FORM FOR SUPPORTING OR OBJECTING TO THE DRAFT CORE PATHS PLAN

Response to Consultation on Proposed Core Path Plan

Draft Core Paths Plan

Map 9
BALLATER

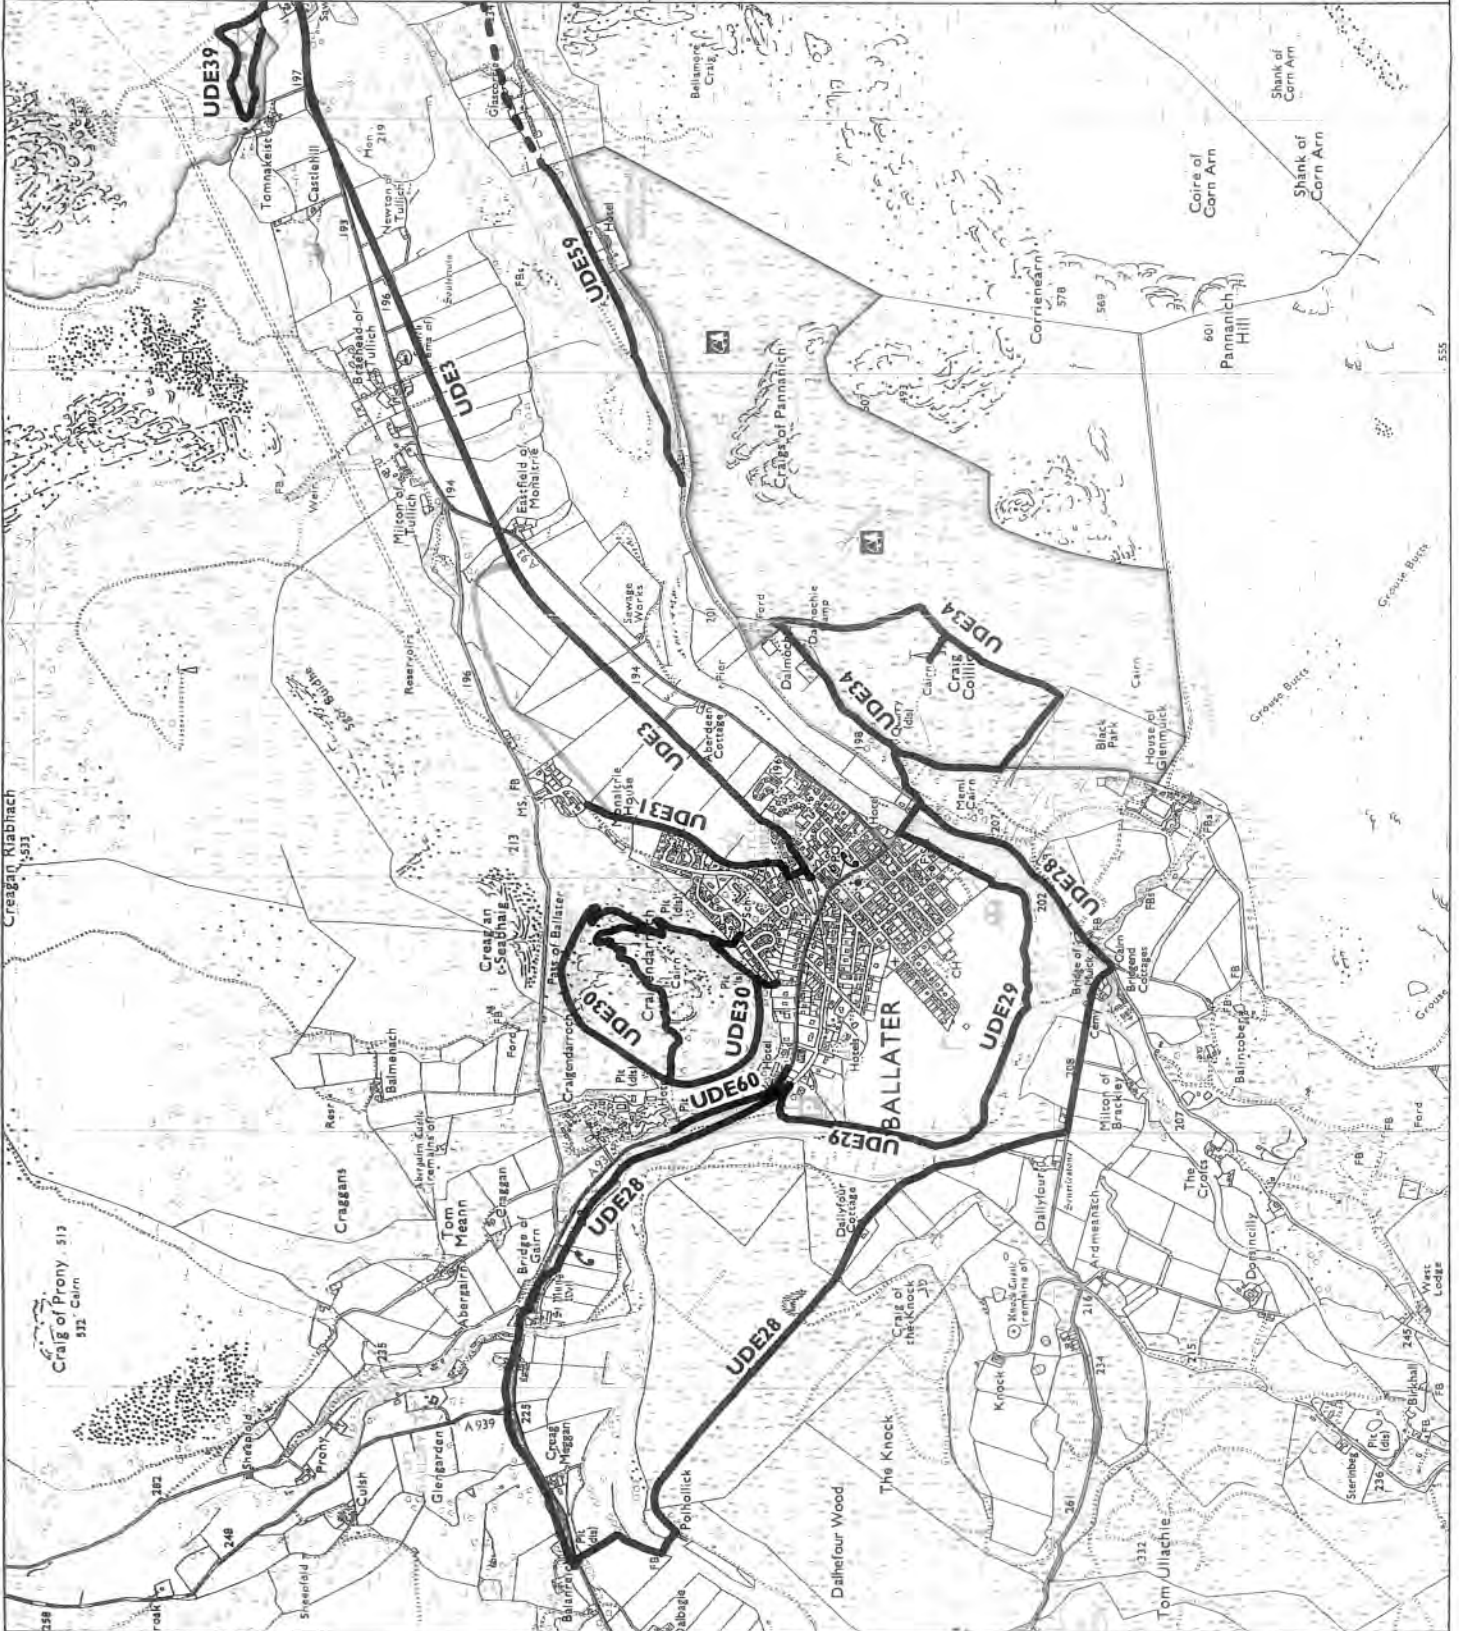
Proposed safe, flat route for
wheelchairs, etc., from Ballater,
approx. 2 miles.

PROPOSED NEW FLAT, SAFE ROUTE.
AVOIDS STEEP SLOPE, A93, PASS OF BALLATER

STEEP SLOPE
NOT SUITABLE
FOR WHEEL CHAIRS
